RE: VIA SENDEROS SUBDIVISION (G10D007A)
Tract F, College Park West
Grading Certification, Engineer's Stamp Date 2/2/2016

RE: **VIA SENDEROS SUBDIVISION** – College Park West, Tract F (G10 – D 007 A)
Drainage Plan for Building Permit (PE Stamped 05-29-08)

Re: Villa Senderos Subdivision Grading and Drainage Plan
Engineer's Stamp dated 2-11-09 (G10/D007A)

**Re: RESPONSE TO COMMENTS FOR VILLA SENDEROS SUBDIVISION
(G-10 – D007A)**

1' HIGH EARTHEN BERM DETAIL
NOT TO SCALE

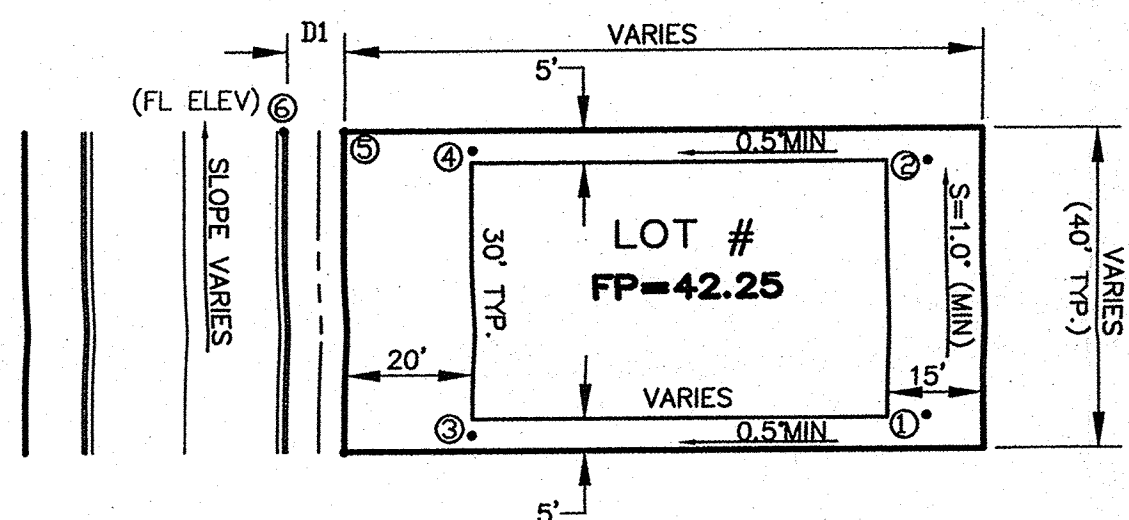
3. Clarify the intent for the "Undeveloped" Parcel, Lot A. Will it be graded? Provide stabilization to keep sediment from entering the public R/W on Tallado Court.

3. the north portion of Tract A will be graded to temporarily retain onsite and offsite runoff. The southern portion of Tract A will have one-foot high earthen berms to provide protection to Tallado Court and to the Rinconada Channel.

TYPICAL LOT GRADING PLAN
NO SCALE

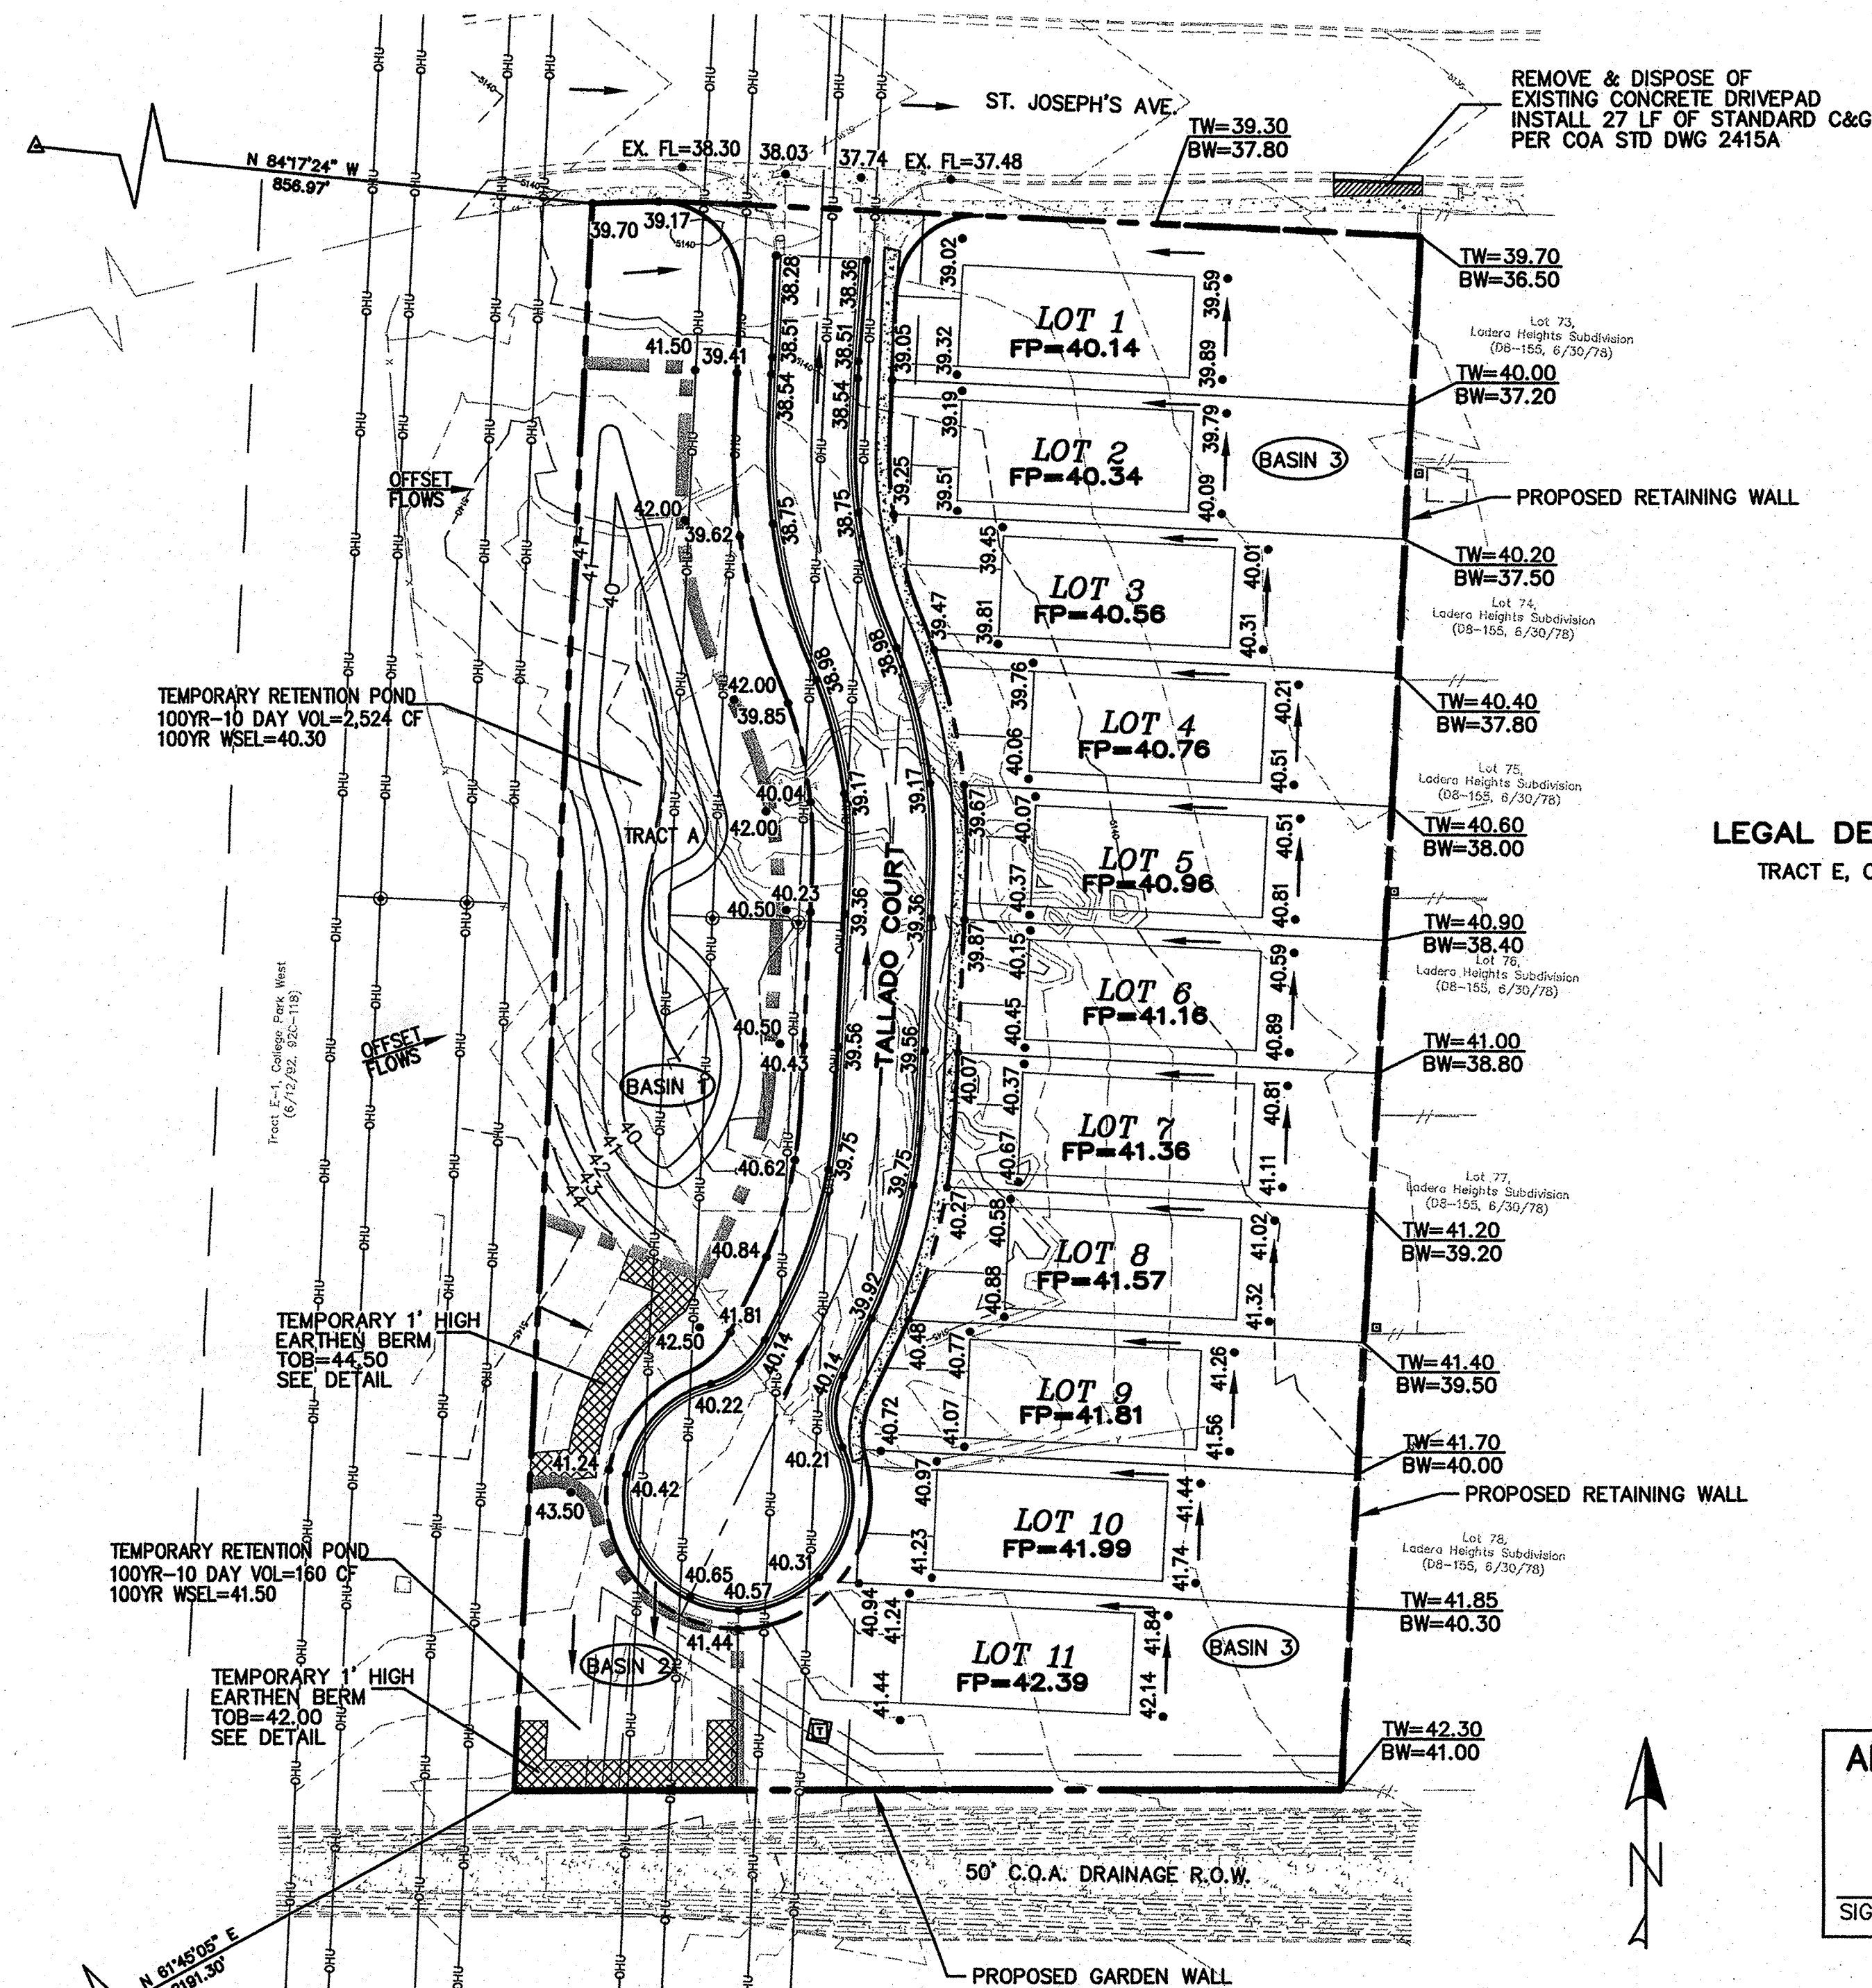
5. In the typical Lot Grading Plan, where is dimension "D1" and should the last note end with a reference to "SPOT ⑥" ?
 6. Since the site is 2.7 acres, remember that a SWPPP will be required.

4. Contours on Tract A have been provided on the revised grading plan.
5. The typical lot grading plan detail has been revised accordingly.
6. We are aware that a SWPPP will be required for the subdivision.
